## VISUAL IMPACTS

- Development Application DP4886: Narrative & Section 18 *Visual Impact Assessment by T. J. DeWan*
- LURC Consultant Jim Palmer *Review of Bull Hill Wind Project Visual Impact Assessment*

**REVISED Palmer Table 1. Maximum Number of Bull Hill Wind Turbines Visible within 8 Miles of Significant Scenic Resources**

From Palmer review of Dewan VIA

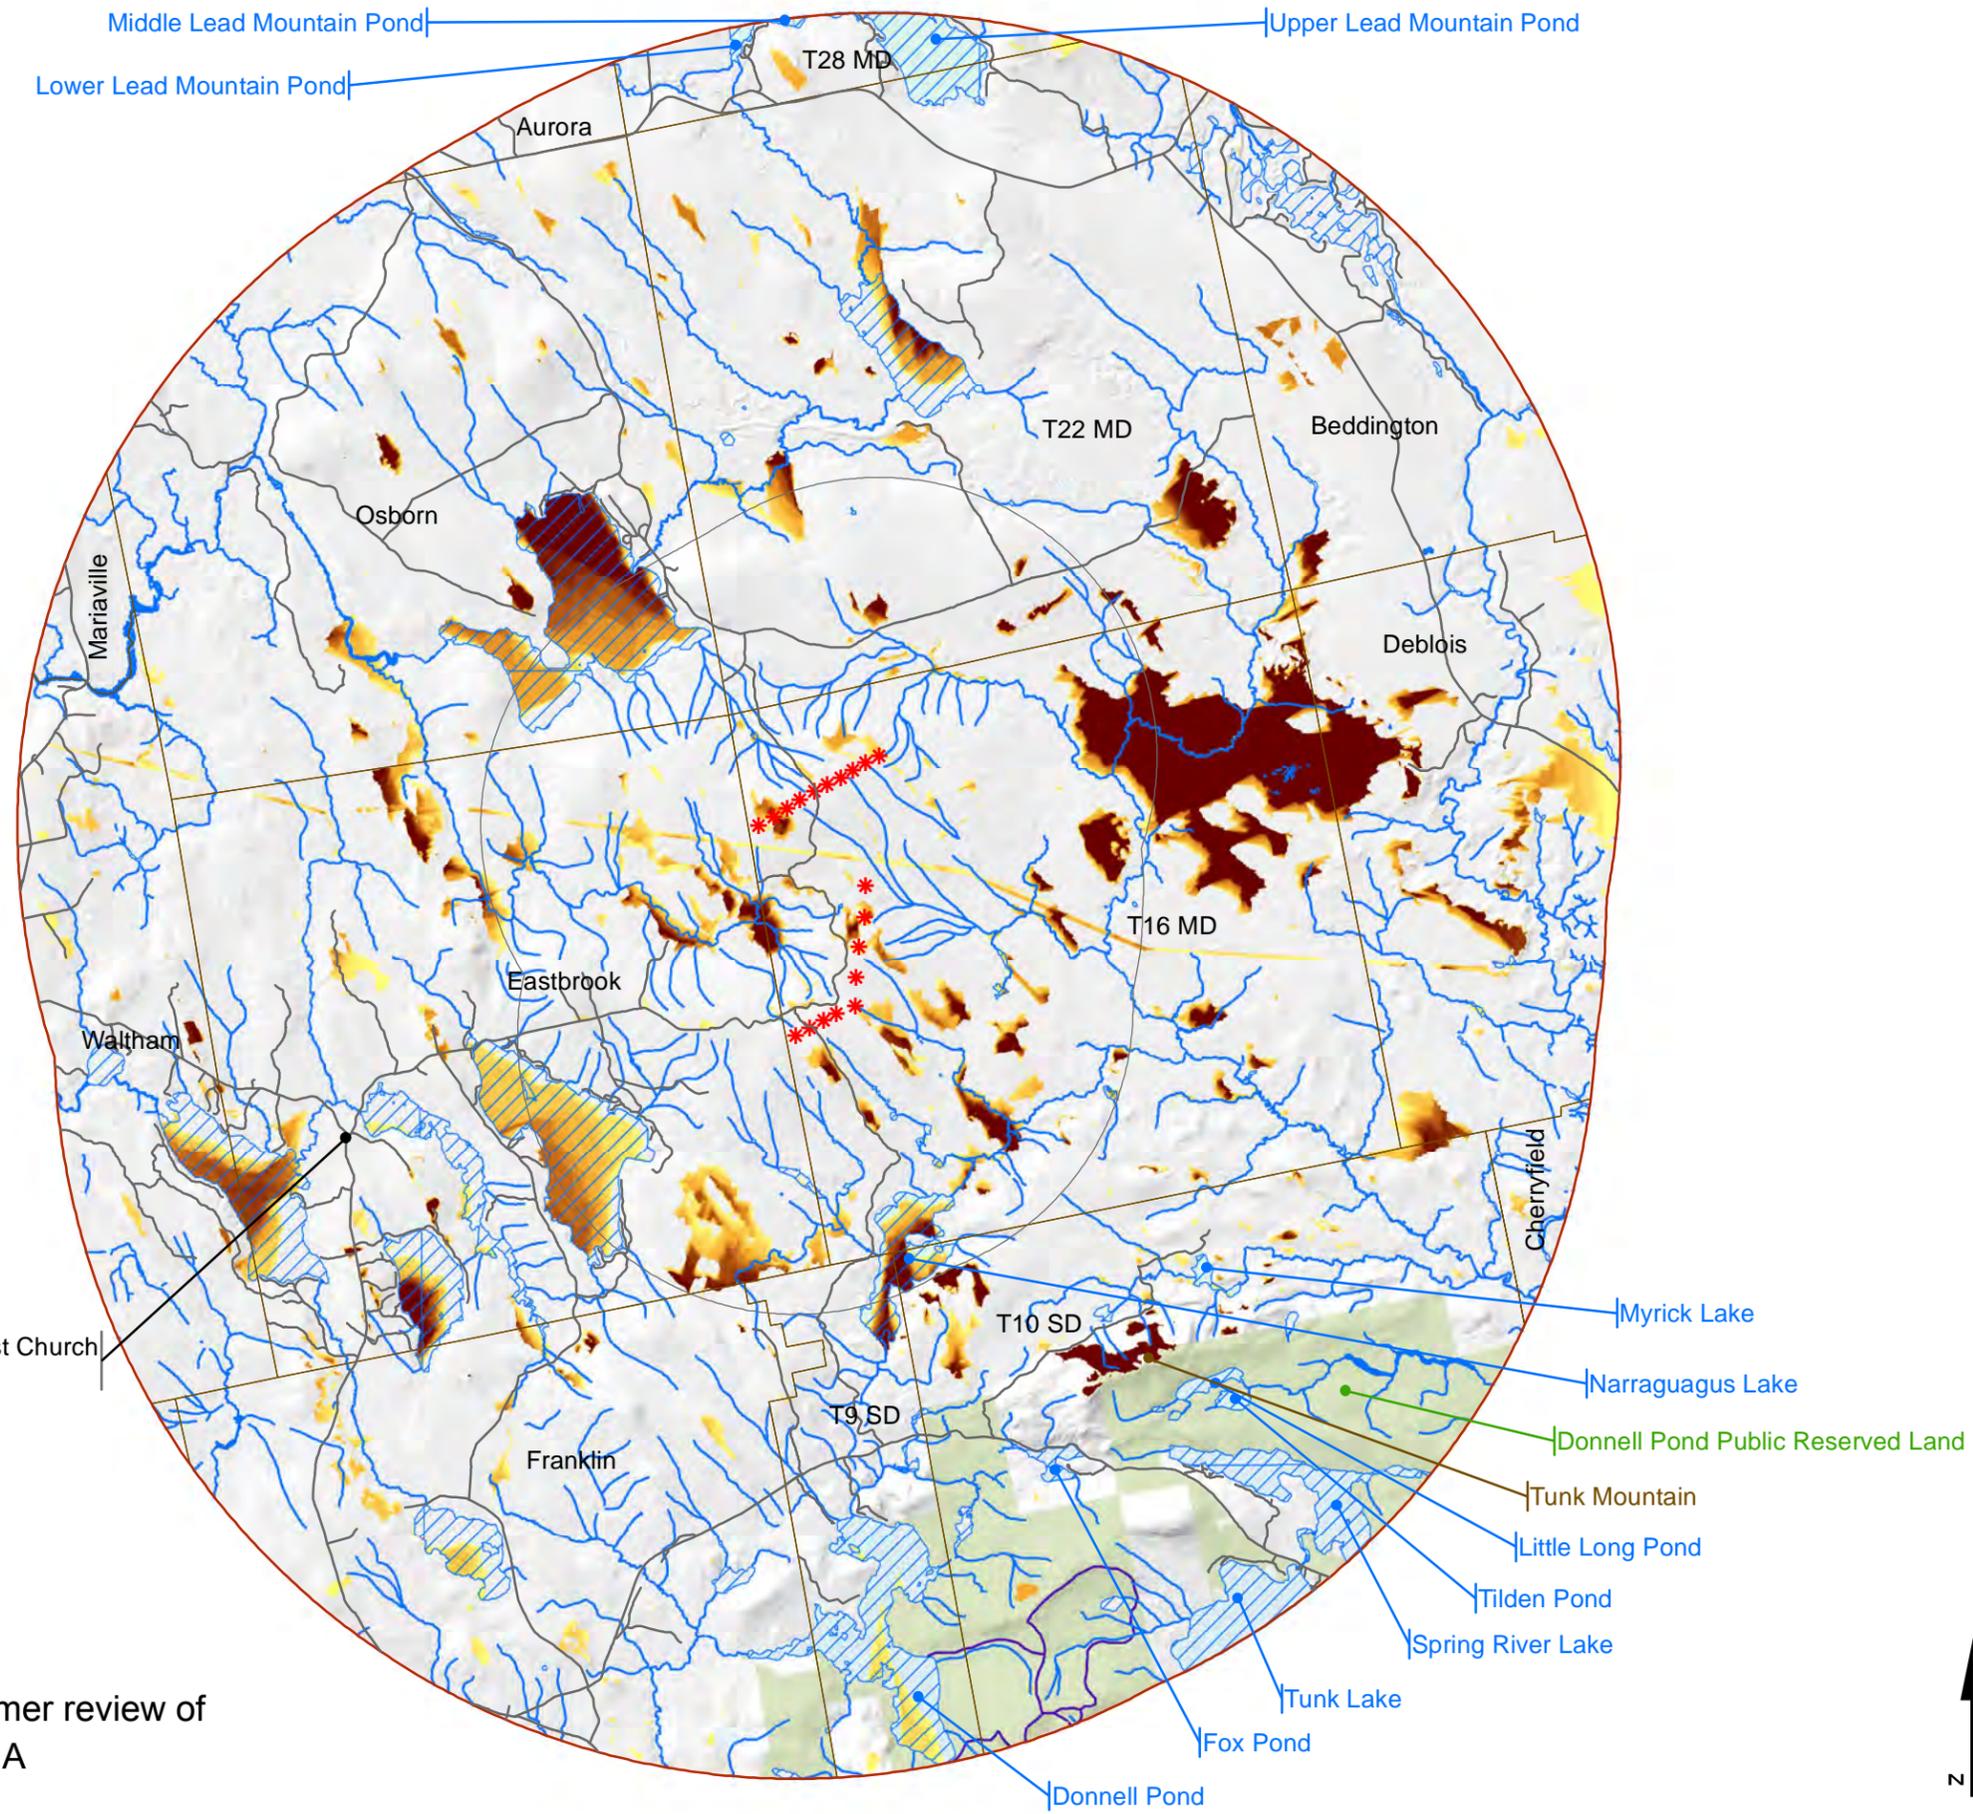
- *Of 14 scenic resources of state or national significance, 8 will have no scenic impact because there is no visibility of the project.*
- *Whether the wind turbines will be visible from Myrick Lake is in question and I was unable to do the fieldwork necessary to verify the visual condition. However, any visibility will be of a modest segment of a relatively few turbines. In addition, Myrick Lake is anticipated to have very low use. Together these two Evaluation Criteria lead to the judgment that the Overall Scenic Impact is Low.*

- *Tunk Mountain is a scenic resource that has been identified as having state or national significance. The Bull Hill wind turbines will have a stronger visual presence than they had from Black Mountain, because they will be much closer. However it is expected that users will focus on the superior view toward the coast (it is a coastal visual resource after all). In addition, Tunk Mountain has no formal access and use is thought to be very light. This may change because the Bureau of Parks and Lands is planning on upgrading and developing trail access, parking and other facilities supporting Tunk Mountain. The combination of very high visual presence from a highly ranked scenic resource and low current use with survey results that indicate that the impact would not affect the likelihood that users would return lead to the judgment that the Overall Scenic Impact is Medium to High, a very Adverse scenic impact, but not Unreasonable.*

**F. PROJECT LIGHTING:****DESCRIPTION:**Application Exhibit 9.0 LIGHTING:

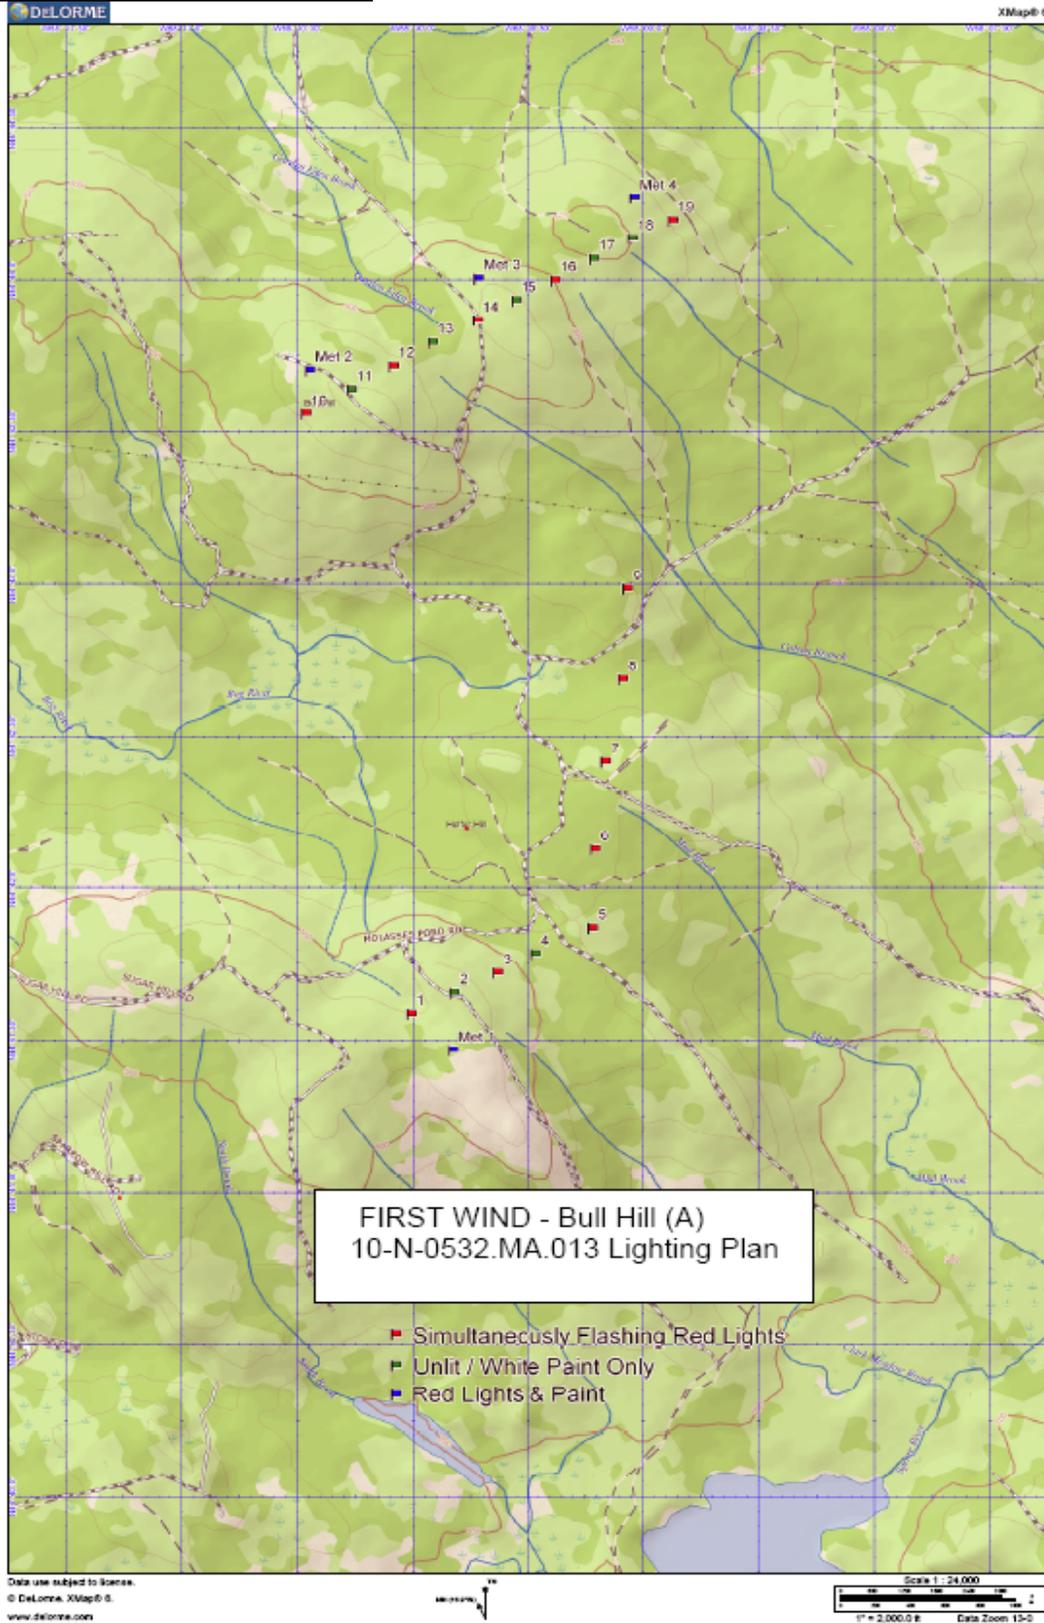
*Questions from LURC: Identify specifically which structures will be lighted. Has the proposed lighting plan been approved by the FAA? Beyond the written description in each resource section of the Visual Impact Assessment (VIA), is there further information about the scenic impacts of the proposed lighting plan? In answering this question, please consider how best to convey this information – a response might include a diagram of which structures will be lighted, a topographic viewshed map of the area in which lights could be seen, a visual simulation, if possible, or other comparable means of providing the information.*

*Response: Blue Sky has submitted a Federal Aviation Administration Lighting Plan as Exhibit 9 to the Application (the "FAA Lighting Plan" or "Plan"). The FAA Lighting Plan was developed to ensure compliance with FAA regulations, 14 CFR part 77. As shown on the Plan turbines 1, 3, 5-10, 12, 14, 16, and 19 will have red aviation warning lights that will be lit at night. In addition, the met towers will have red lights. As further described in the Visual Impact Assessment prepared by Mr. DeWan, and included in Exhibit 18 of the Application, the red lights will be synchronous, pulsing, with a slow-on, slow-off profile. The FAA Lighting Plan showing which turbines will be lit (plus the met towers) can be found at the end of Exhibit 9 of the Application, and has been attached hereto as Exhibit C. The FAA issued its No Hazard Determination approvals for the turbines on December 23, 2010.<sup>1</sup>*
